PUBLIC UTILITIES COMMISSION OF THE STATE OF CALIFORNIA

SAFETY AND ENFORCEMENT DIVISION
UTILITIES SAFETY BRANCHRESOLUTION SU-40
Date: October 9, 1996R E S O L U T I O NRESOLUTION SU-40, ORDER AUTHORIZING RULE CHANGES TO
GENERAL ORDERS (G.O.s) 95 AND 128, RULES FOR
OVERHEAD AND UNDERGROUND ELECTRIC AND COMMUNICATIONS
LINE CONSTRUCTIONSUMMARY

RULES FOR OVERHEAD LINE CONSTRUCTION, GENERAL ORDER NO. 95

F. CLIMBING SPACE IN RACK CONSTRUCTION (See Figure 54-23)

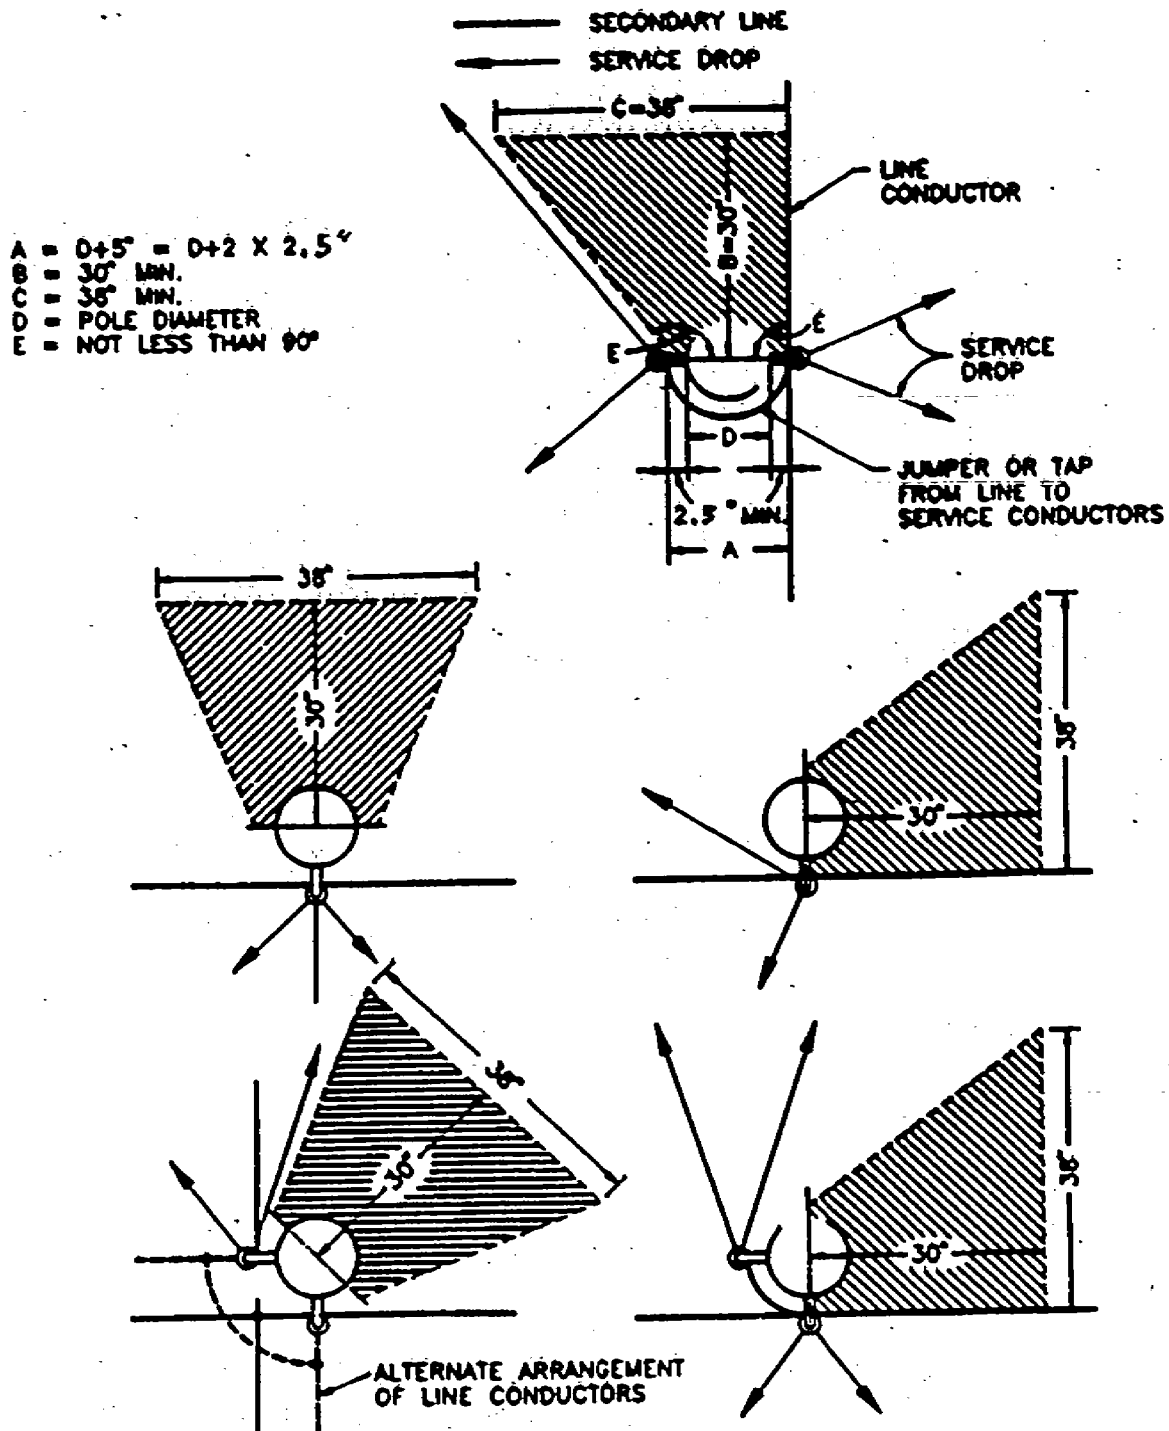
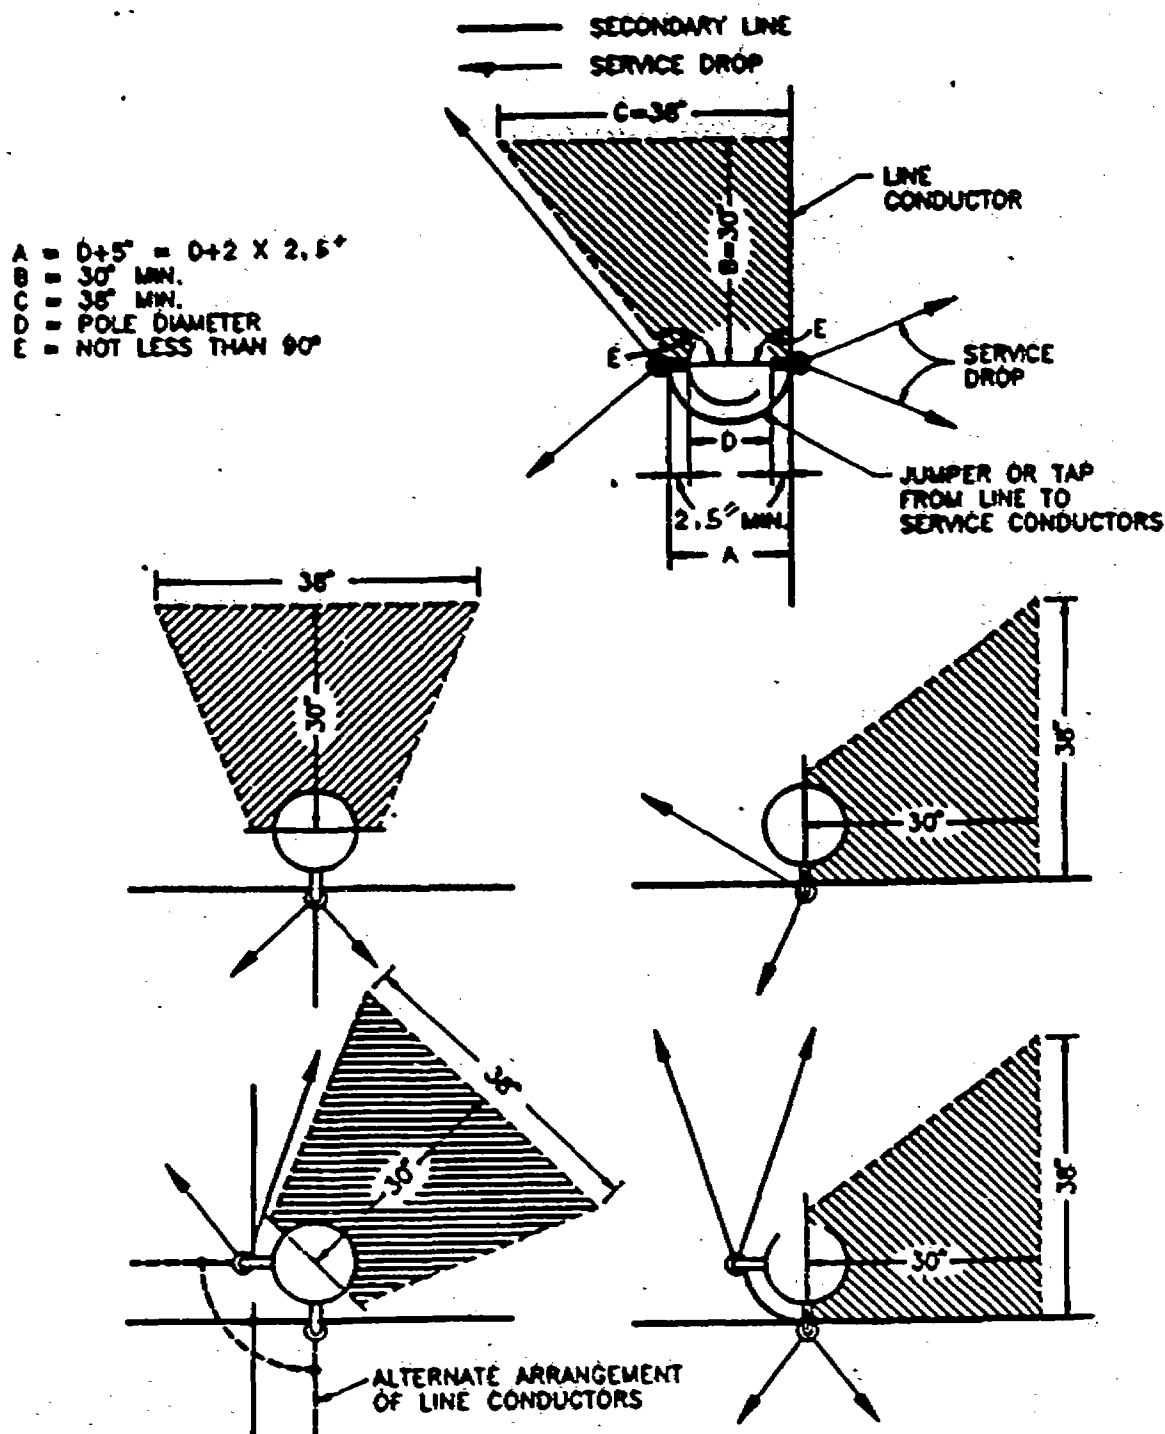
The proposed changes are to simplify and clarify the language in Rule 54.9, and clarify its use in conjunction with Low Voltage Multiconductor Cable with a Bare Neutral, 0-750 volts.
Remove an unnecessary note from Rule 54.9-C2.
Remove an unnecessary portion of Rule 54.9-E1.

F. CLIMBING SPACE IN RACK CONSTRUCTION (See App. G, Fig. 32 see Figure 54-23)

The width of the climbing space measured horizontally through the centerline of the pole shall be not be less than 5 inches plus the diameter of the pole and the extremities of such width shall be equidistant from the centerline of pole. The depth of the climbing space shall be not be less than 30 inches measured perpendicularly to this climbing space boundary through the centerline of pole. The width of the climbing space, perpendicular to and at the extremity of this 30-inch depth dimension, shall be not be less than 38 inches and neither of the other two side boundaries shall make an angle of less than 90 degrees with the boundary through the centerline of pole (see App. G, Fig. 32 (See Figure 54-23)).

Climbing space shall be maintained through the levels of conductors supported in rack construction, for a vertical distance of not less than 4 feet above the top conductor and not less than 4 feet below the bottom conductor so supported. Where conductors in rack construction are installed at pole top, the climbing space shall extend up to the level of lowest conductor of the rack group, and need not be provided through and above such levels.

The width of the climbing space measured horizontally through the centerline of the pole shall not be less than 5 inches plus the diameter of the pole and the extremities of such width shall be equidistant from the centerline of pole. The depth of the climbing space shall not be less than 30 inches measured perpendicularly to this climbing space boundary through the centerline of pole. The width of the climbing space, perpendicular to and at the extremity of this 30-inch depth dimension, shall not be less than 38 inches and neither of the other two side boundaries shall make an angle of less than 90 degrees with the boundary through the centerline of pole (See Figure 54-23).

Figures 54-10 and 54-11

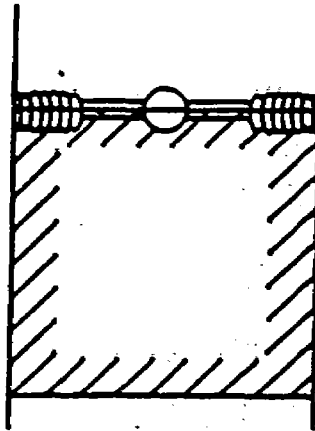
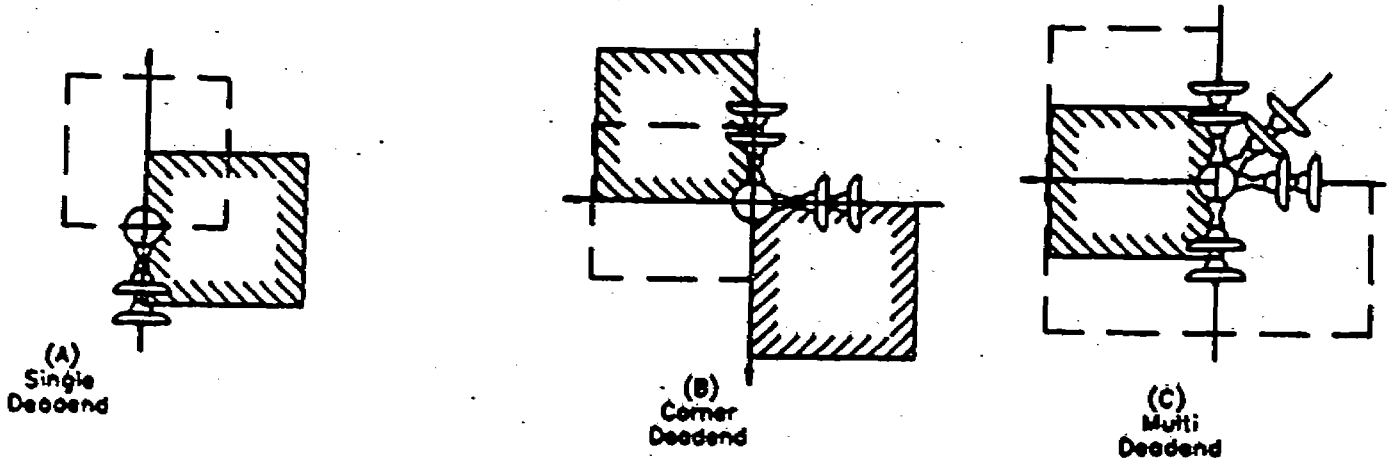
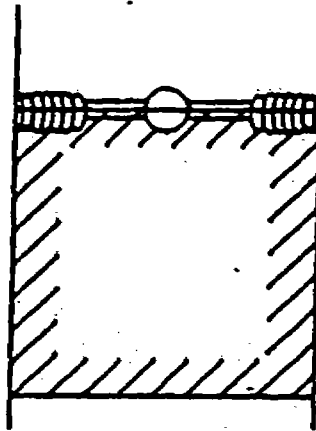
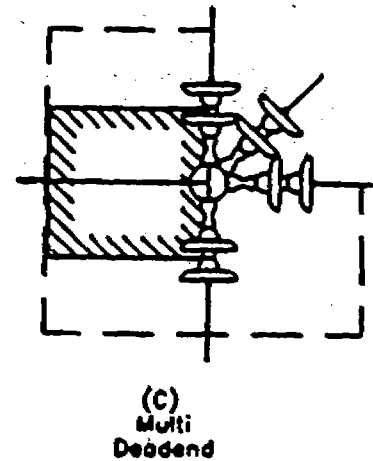
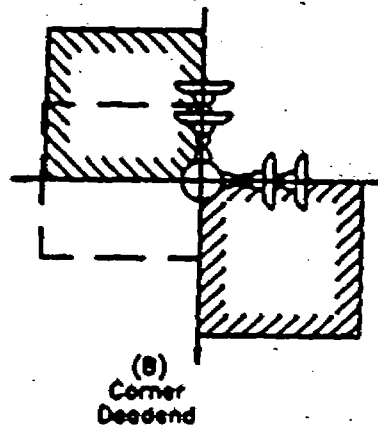
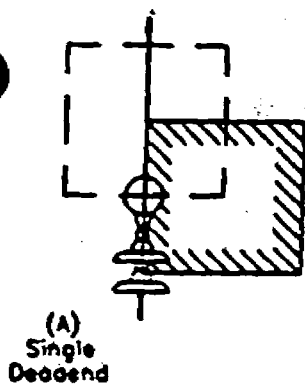
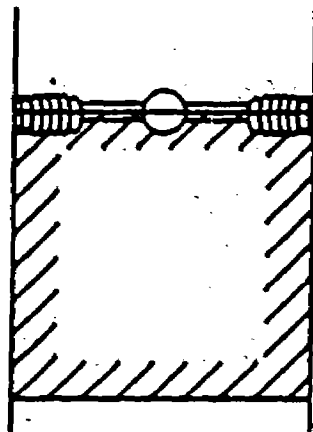
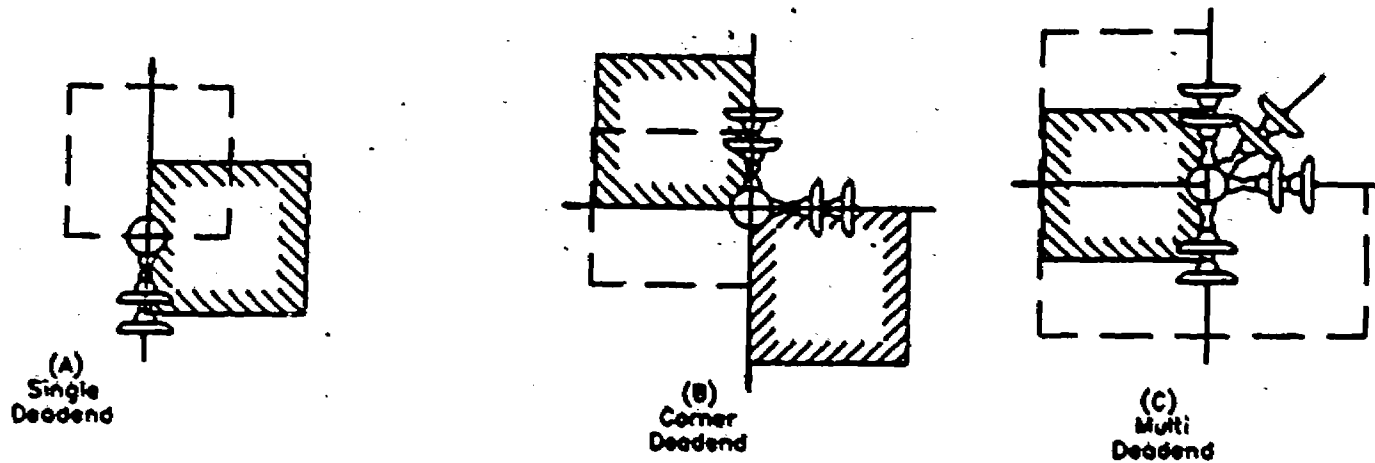
(1) Where Insulators are in Vertical or Horizontal Position ~~(Vertical or Triangular Configuration, more than 750 volts: Climbing space shall be maintained through the levels of conductors for a vertical distance of not less than 4 feet above the top conductor and not less than 4 feet below the lowest conductor. Exception: For a circuit at the top of the pole, the climbing space shall be maintained to the lowest conductor of the circuit on the climbing side of the pole (See Figure 54-10). For a pole top circuit that includes buck position conductors located within a vertical distance of 4 feet or less from the lowest associated line conductor, climbing space need only be maintained to the lowest conductor in the buck position on the climbing side of the pole.~~

(2) ~~Dimensions of Climbing Space Where Conductors are Deadended in Vertical Configuration: Climbing space through conductors shall be a square of the horizontal dimensions tabulated below, and shall be located either on one side or a quadrant of the pole (See Figure 54-11). For a circuit at the top of the pole refer to the exception in Rule 54.11-F.~~

(2) Dimensions of Climbing Space Where Conductors are Deadended in Vertical Configuration: Climbing space through conductors shall be a square of the horizontal dimensions tabulated below, and shall be located either on one side or a quadrant of the pole (See Figure 54-11). For a circuit at the top of the pole refer to the exception in Rule 54.11-F1.
